**THE DATASHEET OF
AM5716AABCDEA**

AM571x (SR 2.0, 1.0) and AM570x (SR 2.0) Sitara™ Processors

Silicon Errata

Literature Number: SPRZ436C
October 2015–Revised February 2017

Figure 4-1. PAB_RevA

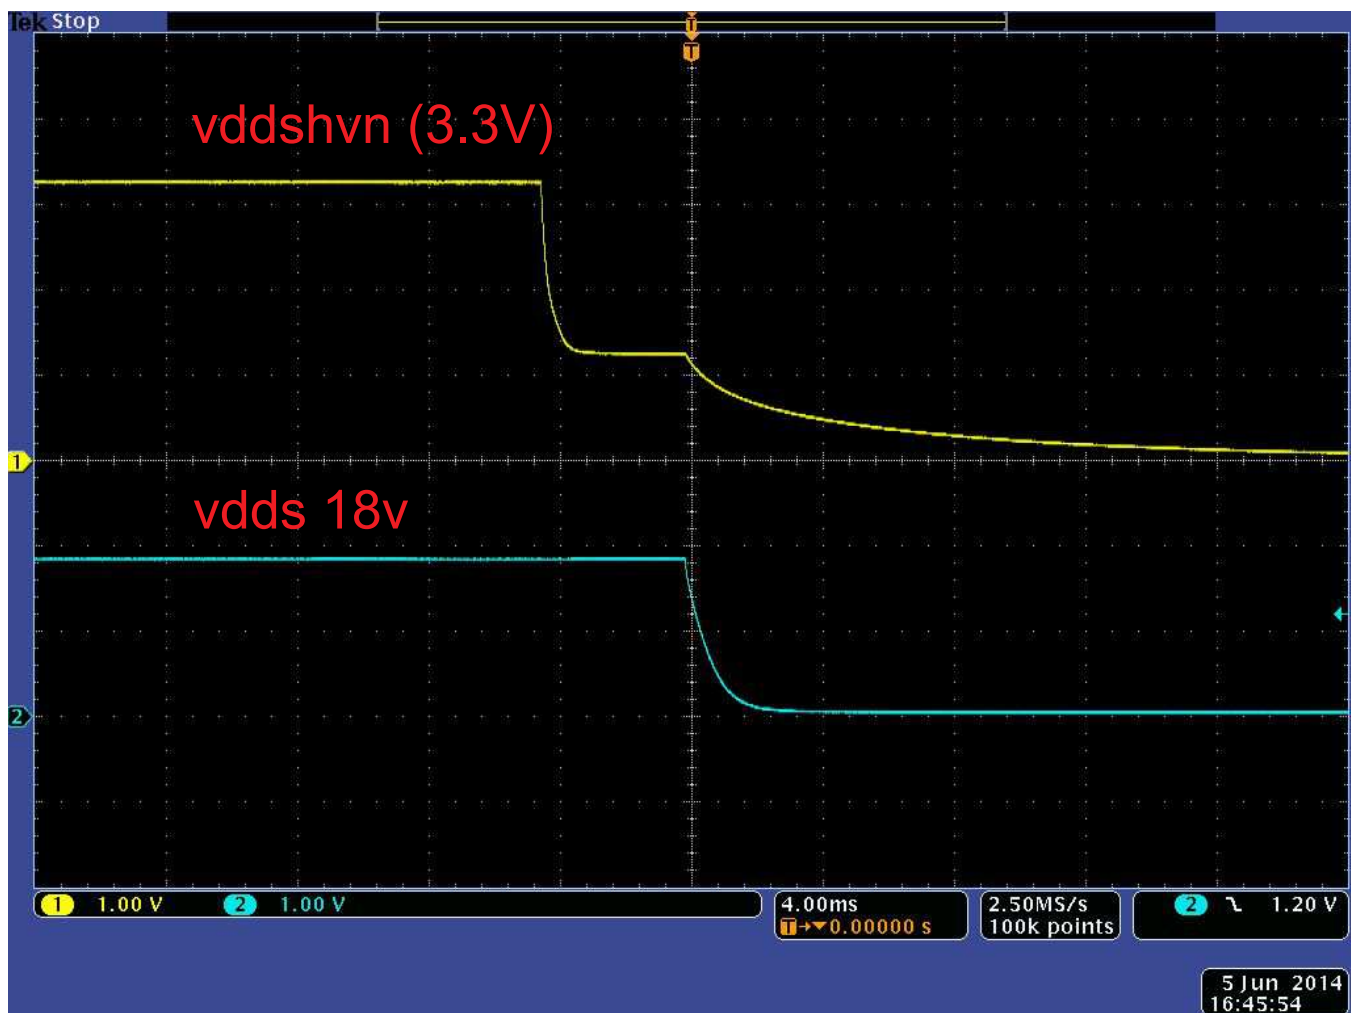
i864 *VDDS18V to VDDSHVn Current Path*
CRITICALITY Medium

For systems that use a different 3.3V supply for the SOC and connected ICs, customers should evaluate their system for reliability risk. If necessary, the PMIC OTP power-down sequence can be modified to delay the vddshv[11:1] powerdown to coincide with the vdds18v powerdown. [Note: The 3.3V rail must never be 2.0V above the 1.8V rail.]

VDDSHV8 is a special case. If VDDSHV8 is powered by the same LDO/switch as the other VDDSHVn rails then the VDDSHV8 rail can also be delayed. However, if the VDDSHV8 rail is supplied by a different LDO (e.g., LDO1 on EVM) than the other VDDSHVn rails, then the sequence should not be modified.
